Technical Note 002		
Project Name and number:	Land off Scotland Road, Melksham	D2424
Subject:	Response to Planning Consultation (EA)	
Client:	Brant Storage	
Prepared by and Date:	MJA	20/07/2026

BP Civils has previously prepared a Flood Risk Assessment and Drainage Strategy (D2424 FRA 1.0, dated February 2026) in relation to the retrospective application for the storage of up to 72 No storage units on the former car park area of cooper tyres. A planning application was submitted to Wiltshire Council ref: PL/2025/09205.

The EA has commented, dated 2nd April 2026:

Figure 8 - Maximum predicted extent and depth of flooding during the 1 in 1000 year return period flood event (i.e., Flood Zone 2).
(© Environment Agency - contains Ordnance Survey data © Crown copyright and database right 2026).

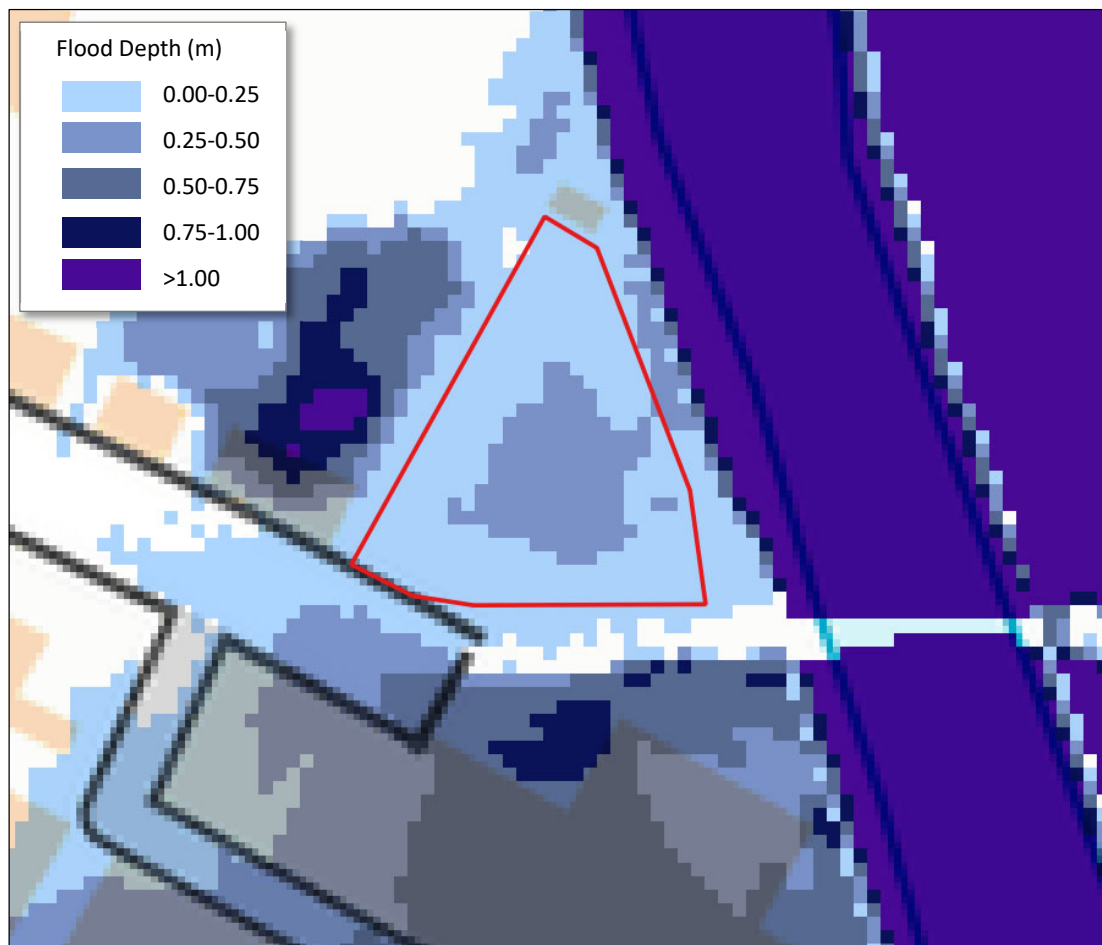
Although the drawings show a 200mm freeboard beneath the storage containers, we require site specific flood depth information to determine whether this clearance is sufficient to avoid impeding flood flows.

- 6.2.1. As Figure 3 identifies that the site is located within Flood Zone 2, it is also necessary to appraise the risk of flooding from the 1 in 1000 year return period event. Whilst this flood event is considered to significantly overestimate the risk of flooding to the site, in order to overcome the EA's objections, the 1 in 1000 year return period event has been appraised as a precautionary approach to fully understand the risk of flooding to the site.
- 6.2.2. The results under this scenario show that the entire site could flood to a predicted flood level of between 35.70m and 35.75m AODN (Figure 8). When this is compared to land levels onsite within the topographical survey, the results show that the site could flood to a predicted depth of **0.04m - 0.38m**.

- 7.2.2. As identified in Section 6.2.2 above, the depth of flooding onsite is shown to vary between 0.04m and 0.38m under the 1 in 1000 year return period event. Therefore, it is recommended that the storage containers are raised proportionately with the existing ground levels respective to their location onsite. As the maximum flood depth onsite is found to be 0.38m, best practice would recommend that all the storage containers are raised 600mm above the existing ground level to ensure that the containers are raised above the maximum predicted flood level.

Figure 9 – Location of site in relation to the flood defence infrastructure and the 8m easement along the site outlined in green. (Contains Ordnance Survey data © Crown copyright and database right 2026).

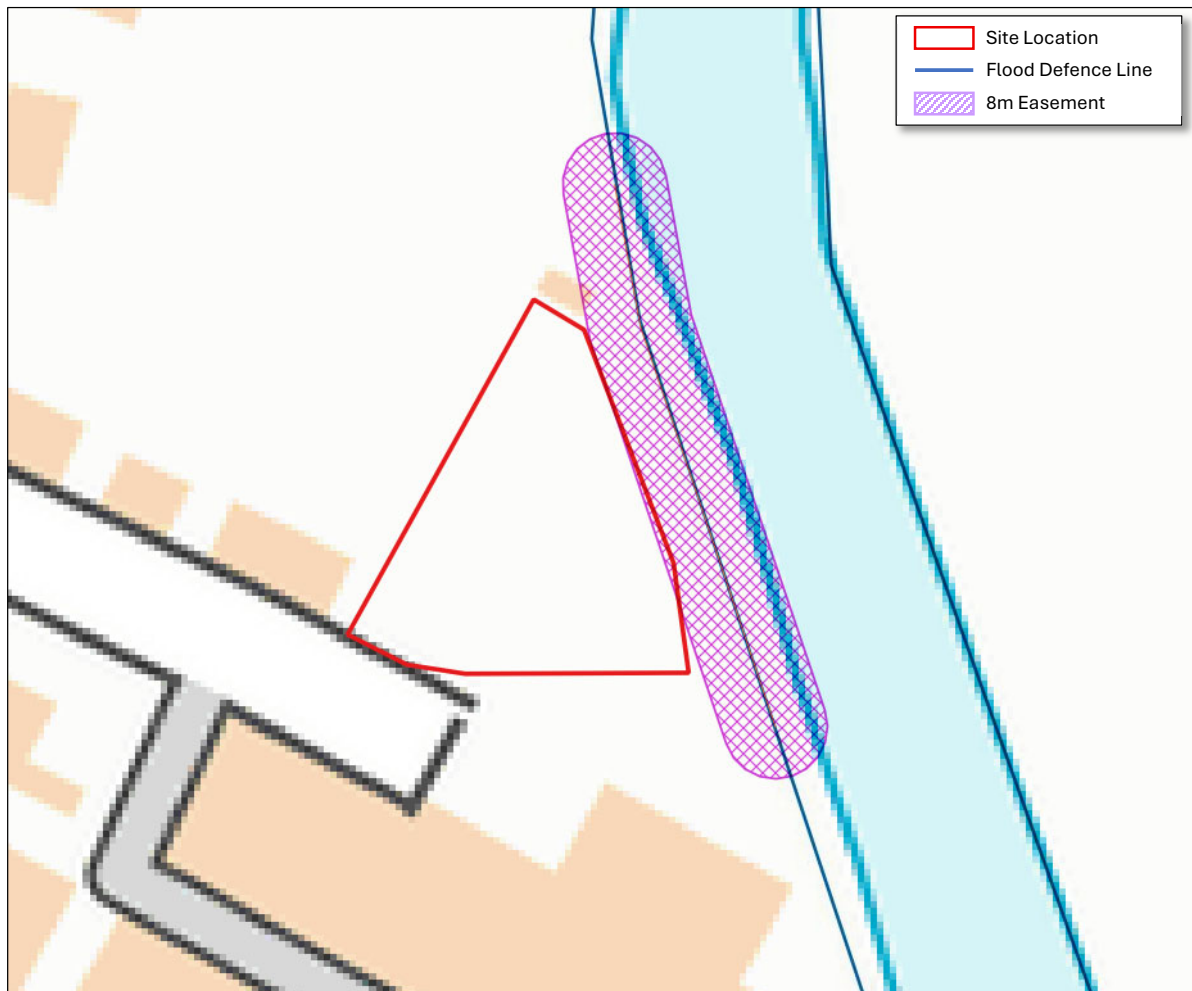
Furthermore, any containers located within 6m of the top of the riverbank must be moved to achieve a minimum 8m offset. This is necessary both to protect the stability of the bank and to avoid increasing flood risk.

- In the first instance, it is recommended that the storage containers are raised 600mm above the existing ground levels. Freeboard should be used to create a void to allow any potential floodwater to flow freely beneath the storage contained and not be displaced elsewhere.
- In addition, in order for the proposals to meet the requirement of the EA's 8m buffer zone between the riverbank, it has been recommended that the proposed storage containers be positioned behind this 8m easement as demonstrate on Figure 9 above.

- 7.3.3. In this case, within the response to the previous planning application the EA have raised concerns over the impact of the proposed storage containers located within the 8m buffer zone. In addition, review of the EA's 'Spatial Flood Defence' mapping reveals that the site is located approximately 6m from the defence infrastructure along the River Avon. Therefore, it is recommended to re-locate the proposed storage containers to achieve a minimum of 8m easement in accordance with the EA's requirements. Figure 9 below shows the location of the 8m easement from the flood defence infrastructure along the River Avon for the proposed storage containers to be relocated behind;
